# SERVICE BULLETIN

Classification: <b>FA00-003a</b>	Reference: <b>NTB00-030a</b>	Date: <b>June 19, 2000</b>
-------------------------------------	---------------------------------	-------------------------------

## 2000 MAXIMA RIGHT FRONT STRUT NOISES

**APPLIED VEHICLE:** 2000 Maxima (A33)

Figure 1

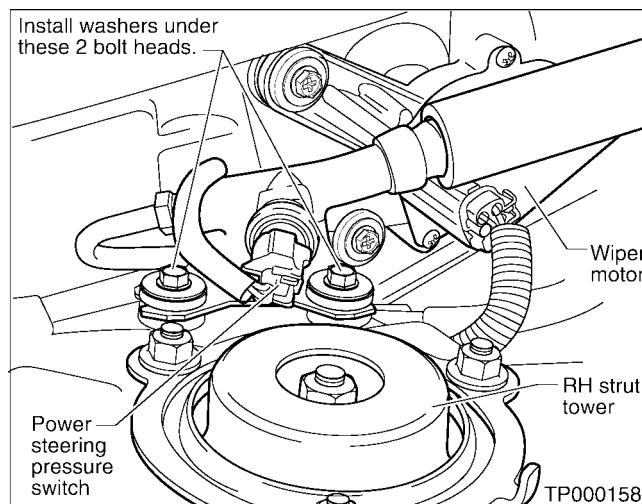
1. Add one washer to each bolt for the power steering switch bracket (see Figure 1).

Figure 2

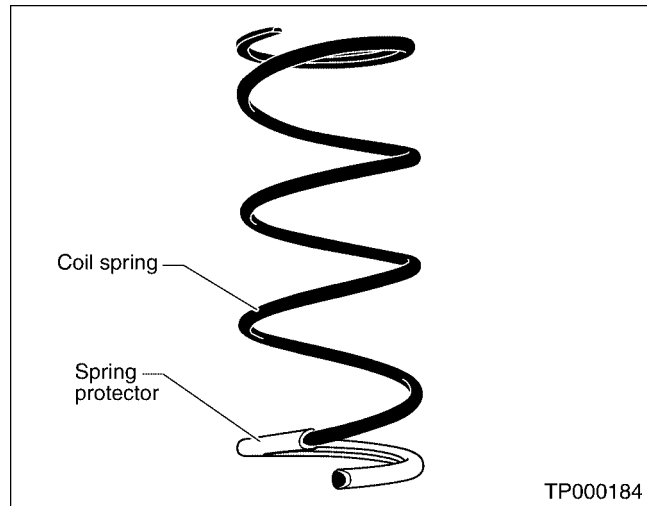
4. Remove the gray spring protector (see Figure 2) from the spring.

Figure 3

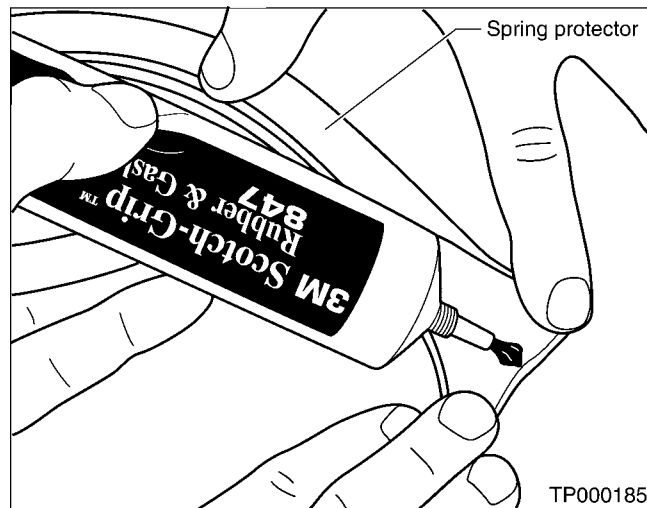
5. Apply a bead of 3M Scotch-Grip™ Rubber and Gasket Adhesive P/N 847 (or equivalent) to the center of the spring protector (see Figure 3). Lay the bead along the entire inside length of the spring protector.

Figure 4

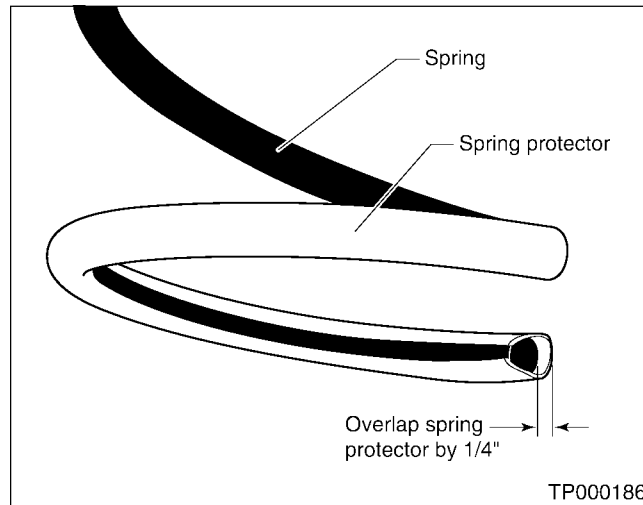
6. Install the gray spring protector back onto the spring so the protector overlaps the end of the spring by 1/4" (see Figure 4).

Figure 5

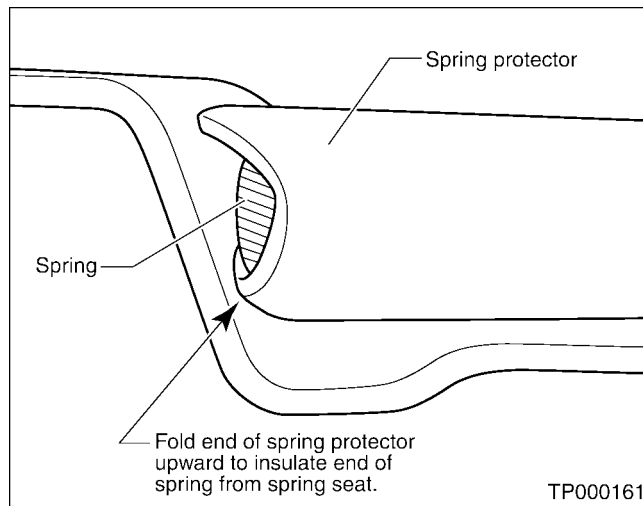
7. Set the spring back onto the lower seat. Fold the end of the spring protector upward so the end of the spring is protected from the lower seat (see Figure 5).

Figure 6

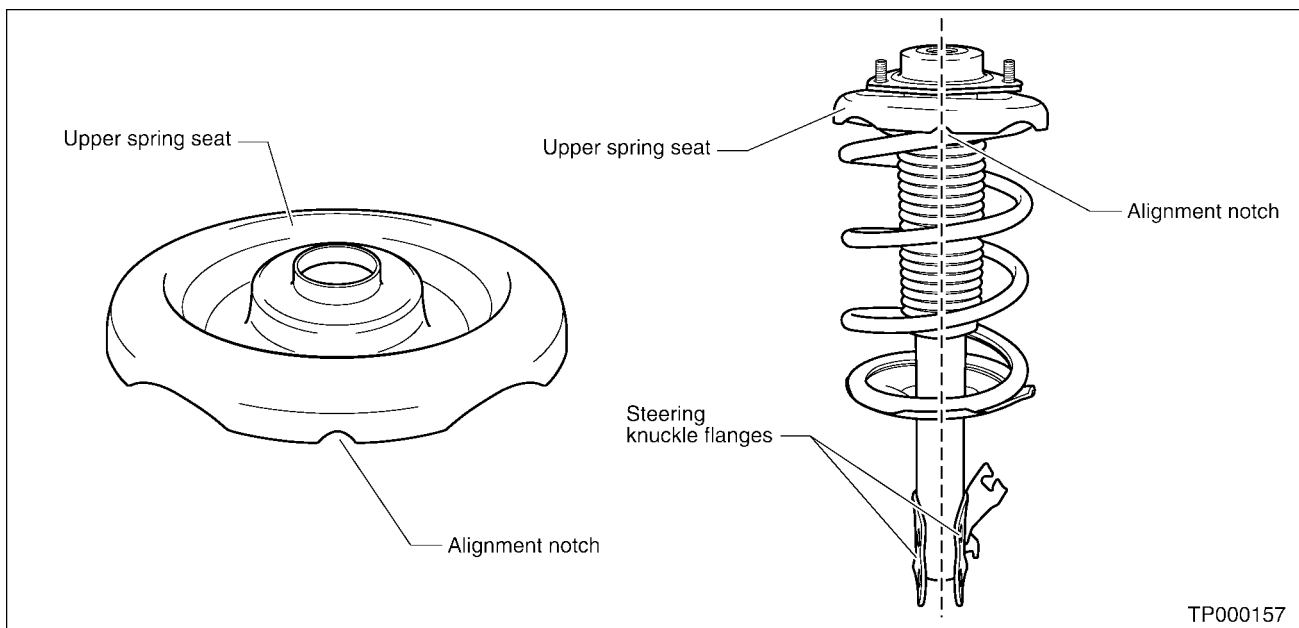
- A. Reassemble the strut with the new upper seat rubber with the one from the Parts Information section of this bulletin.
- B. Make sure the spring protector is still folded upward from step 5, protecting the spring seat.
- C. During strut re-assembly, note the upper spring seat alignment. Make sure the "notch" in the upper spring seat is aligned as shown in Figure 6.

**NOTE:** The "notch" **MUST** be centered, right in the middle, between the steering knuckle flanges on the lower part of the strut.
